SERVICE BULLETIN

M-1224

Safety Recall Code 0135

2008 Touring Fuel Filter Shell Recall

Figure 1. Fuel Tank Top Plate

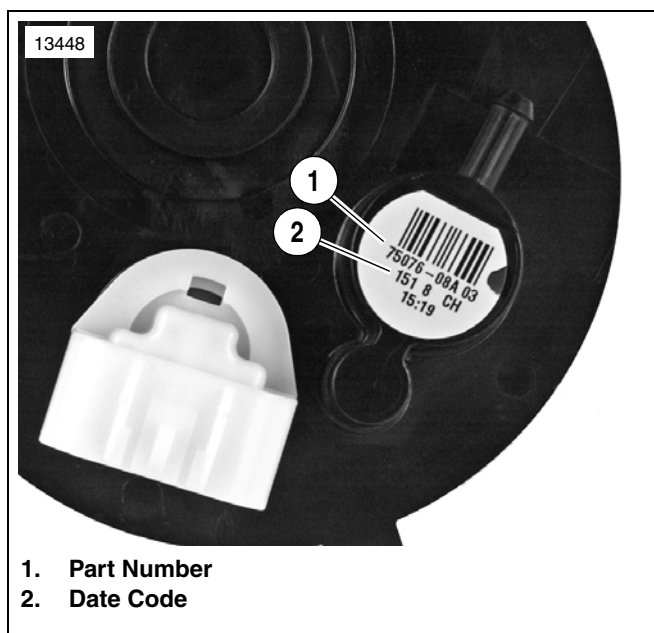
1. See Figure 1. Remove dash housing/center console. See FUEL TANK TOP PLATE in the Touring Models Service Manual.
2. Inspect decal with part number and date code on fuel tank top plate.
 - If part number (1) is 75069-08A or 75076-08A, then install dash housing/center console. No replacement is required.
 - If part number (1) is 75069-08 or 75076-08 with a date code (2) of 267 7 (267th day of 2007) or later, then install dash housing/center console. No replacement is required.
 - If the part number is 75069-08 or 75076-08 and has a date code earlier than 267 7, continue disassembly to replace the fuel filter shell using the **new** filter shell and o-ring provided in the kit.

3. Remove fuel filter shell. See FUEL FILTER in the 2008 Touring Models Service Manual.
4. Remove fuel filter and fuel pressure regulator and install on **new** fuel filter shell (included in kit.) See FUEL PRESSURE REGULATOR in the 2008 Touring Models Service Manual.
5. Carefully remove fuel line retainers and install on **new** fuel filter shell. See FUEL TANK TOP PLATE in the Touring Models Service Manual.
6. Install **new** fuel filter shell with **new** o-ring (included in kit). See FUEL FILTER in the 2008 Touring Models Service Manual.
